4 CIRCUIT POWER CONNECTOR

Foils presented by Jim McGrath (Moler) February 19, 1991

X 379.2/91-23

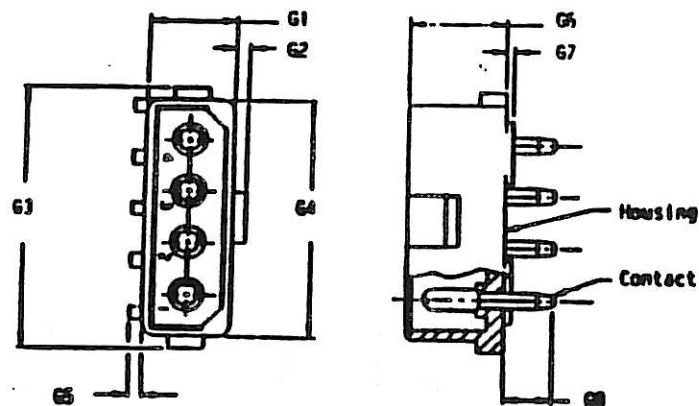
- ✓ ESDI DOES NOT SPECIFY CRITICAL INTERNAL DIMENSIONS OF THE 4 CIRCUIT POWER CONNECTOR.
- ✓ LACK OF A DEFINED INDUSTRY STANDARD HAS CREATED PLUG COMPATIBILITY PROBLEMS AMONG COMPONENTS OF THE DISK DRIVE POWER SUPPLY DISTRIBUTION SYSTEM, WHICH INCLUDES:
 - POWER SUPPLY OUTPUT CABLE
 - POWER DISTRIBUTION HARNESS
 - DISK DRIVE POWER INPUT CONNECTOR

FIGURE 13: J3/P3 POWER CONNECTOR

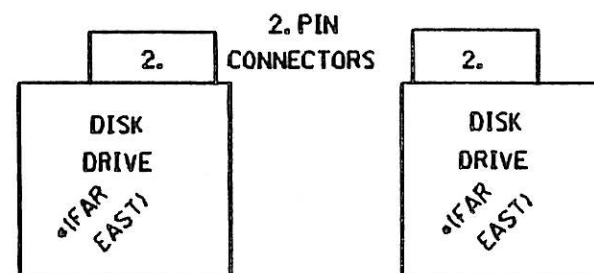
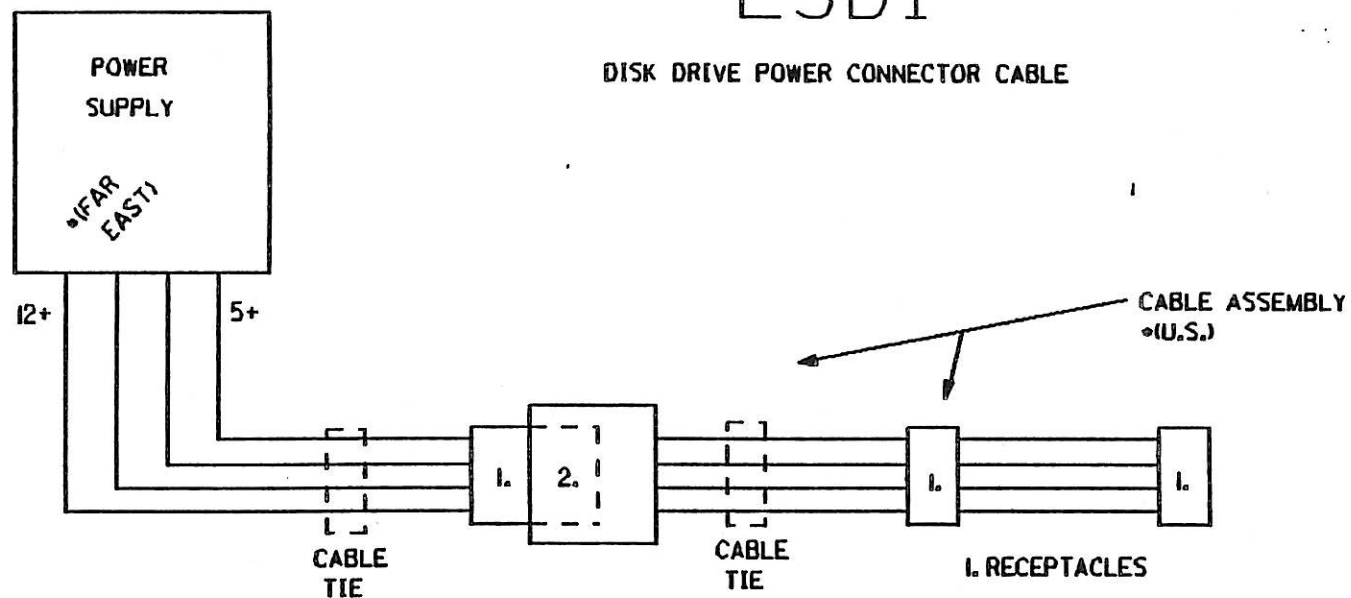
- ✓ WE HAVE ASSUMED THIS IS AN .084 PIN SYSTEM
- ✓ SEVERAL CONNECTOR MANUFACTURERS HAVE TARGETED .084 PIN DIAMETER SYSTEMS WHILE OTHERS HAVE TARGETED .0825 AND .081 PIN DIAMETER
- ✓ ONE MANUFACTURER HAS TARGETED A 2mm PIN (.079)
- ✓ BASED ON THE ABOVE, INDUSTRY PIN DIAMETERS COULD RANGE FROM .077 (.079 +/- .002) TO .086 (.084 +/- .002)

THIS LARGE RANGE OF PIN DIAMETERS CAUSES:
INTERMITENT CONTACT

EXTREMELY HIGH PLUGGING FORCE

- ✓ ANOTHER PROBLEM INVOLVES REVERSE PLUGGING
DUE TO :
 - LACK OF DEFINED INTERNAL DIMENSIONS
AND TOLERANCES OF THE CONNECTOR HOUSING
 - USE OF SOFT NYLONS FOR BOTH PLUG
AND RECEPTACLE HOUSINGS
- ✓ THE ABOVE COMBINED WITH ANTICIPATED HIGH
PLUGGING FORCE (DUE TO PIN DIA.) ALLOWS
THE POLARIZATION FEATURE TO BE DEFEATED.

✓ SUGGESTION: STANDARDIZE PIN DIAMETER AT
.0825 +/- .001

BECAUSE IT WILL MINIMIZE PROBLEMS WITH BACKWARD
COMPATIBILITY DURING AND AFTER STANDARDIZATION.

✓ SUGGESTION: SPECIFY MIN-MAX INSERTION AND
WITHDRAWAL FORCES FOR THE RECEPTACLE.
